LRN-01-0412
LCR S01-08

**EXIGENT REQUEST FOR CHANGE TO TECHNICAL SPECIFICATION 3/4.7.4
SERVICE WATER SYSTEM
SALEM GENERATING STATION UNIT NO. 1
FACILITY OPERATING LICENSE DPR-70
DOCKET NOS. 50-272**

**SALEM GENERATING STATION
UNIT NO 1
DOCKET NOS. 50-272
CHANGE TO TECHNICAL SPECIFICATIONS**

FIGURE 1
SALEM UNIT 1 SERVICE WATER SYSTEM

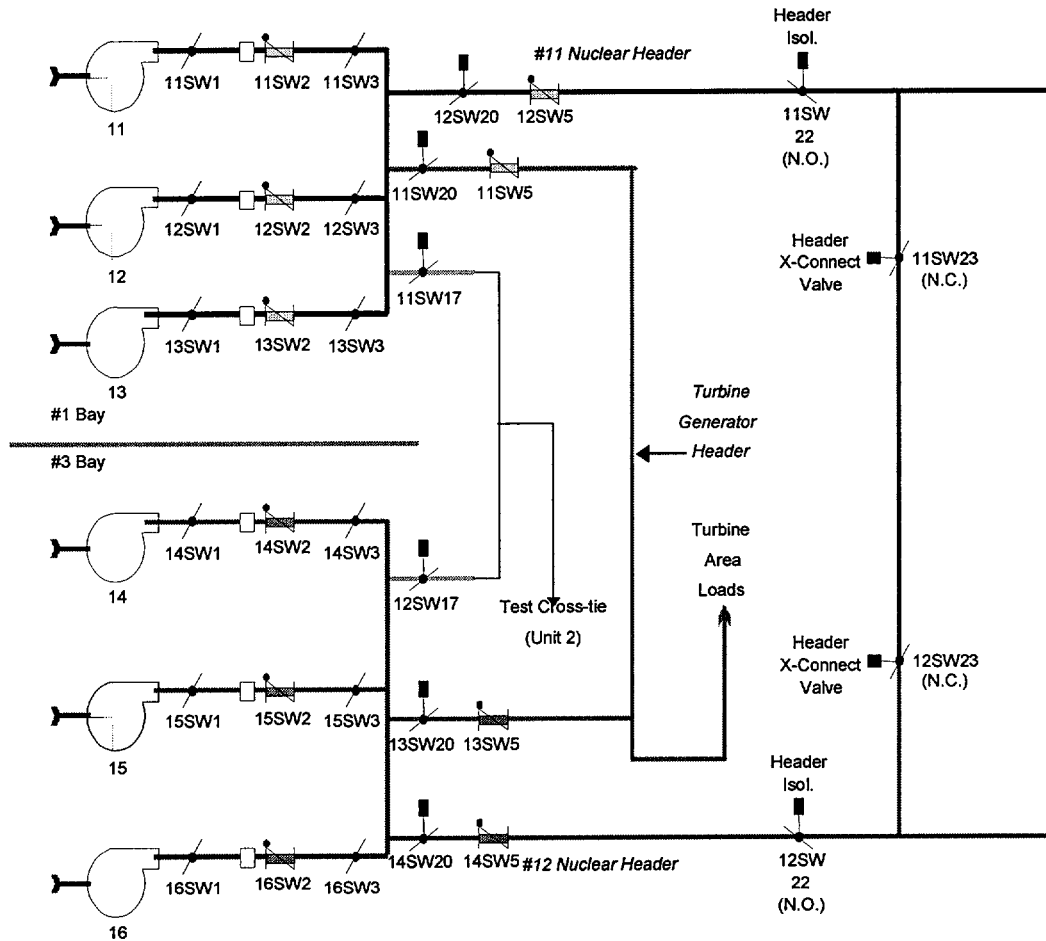
On Friday morning, November 30, 2001, Operations personnel noted water rising up through the gravel in front of the Service Water intake structure. The water was located approximately five feet from the structure and seven feet from the north side stairs, the 12 Service Water nuclear header is located below the location where the water was observed and was considered to be a likely source of the leak.

Subsequent investigation and troubleshooting determined that the leak is associated with the 12 Service Water nuclear supply header. This determination was partially based on the use of a dye test. Based on the information currently available, the leak is postulated to be at an underground mechanical joint or mechanical connection associated with the buried portion of the 12 Service Water nuclear supply header located near the Service Water structure. A simplified diagram of the service water system is provided in Figure 1.

To perform the selected repair method, the buried portion of the 12 service water nuclear header will be isolated such that all six service water pumps will be available and capable of supplying cooling water to the safety related equipment via the redundant nuclear header (number 11 header). In this configuration, the UFSAR assumption that two pumps per bay, and at least one powered from each vital bus, are available to mitigate the consequences of a Loss-of-Coolant Accident with a loss of power is maintained. To isolate the leaking section of the buried portion of the 12 nuclear header, the number 3 service water intake bay will be isolated temporarily to permit installation of a blind flange. The total period of time during which the number 3 bay is isolated will be limited to less than the 72 hours currently permitted by TS 3/4.7.4.

During the repair to the 12 nuclear service water header, the header will be isolated such that all six service water pumps will be available and capable of supplying cooling water to the safety related equipment via the redundant nuclear header (number 11 header). To isolate the leaking section of the 12 nuclear header, the number 3 service water intake bay will be isolated temporarily to permit installation of a blind flange. The total period of time during which the number 3 bay is isolated will be limited to less than the 72 hours currently permitted by TS 3/4.7.4.
